Subject: Duke Energy Carolinas, LLC
Oconee Nuclear Station, Units 1, 2 and 3
Renewed Facility Operating Licenses Numbers DPR-38, 47 and 55;
Docket Number 50-269, 50-270 and 50-287;
Supplement to License Amendment Request for Measurement Uncertainty
Recapture Power Uprate,
License Amendment Request No. 2011-02, Supplement 2

Response to NRC Request for Additional Information

Attachment 3

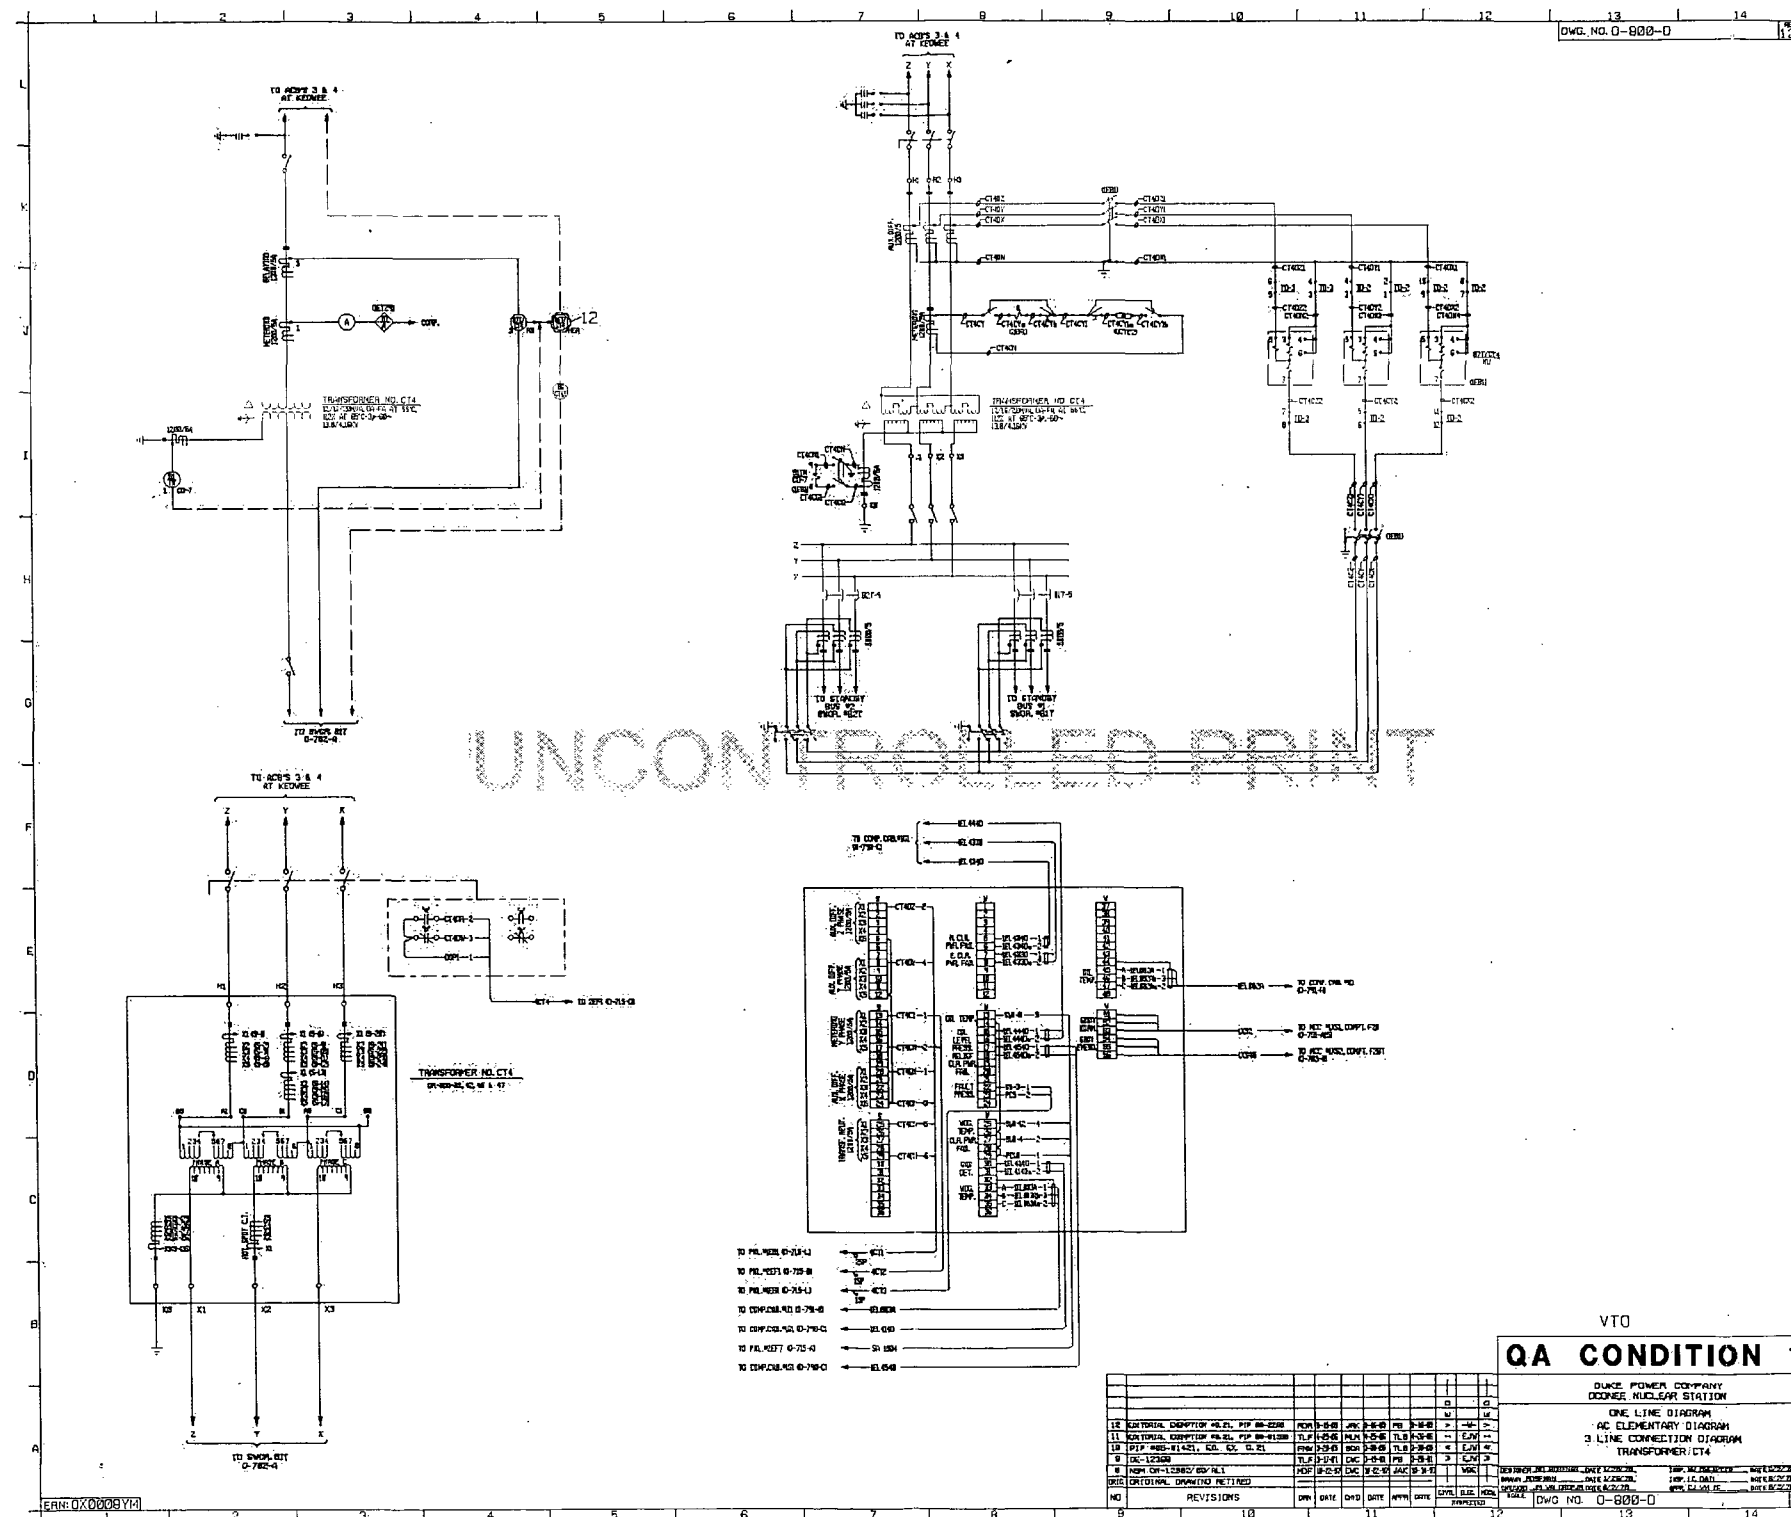
Provide a current main single line diagram that identifies and shows the interconnection of the equipment described in this section. Provide a summary of the evaluation that supports your conclusion that plant operation under MUR power uprate conditions are bounded by the loading tables as indicated in Section V.1.A of the LAR.

A summary of the evaluation that supports the conclusion that plant operation under MUR power uprate conditions are bounded by the loading tables is provided as follows. The current ETAP model is already conservative enough to exceed loading increases required for achieving the MUR power uprate. For this reason, there is no change to the AC Distribution Systems for the MUR power uprate. Therefore, the rating of the Keowee Hydro Units will not be exceeded.
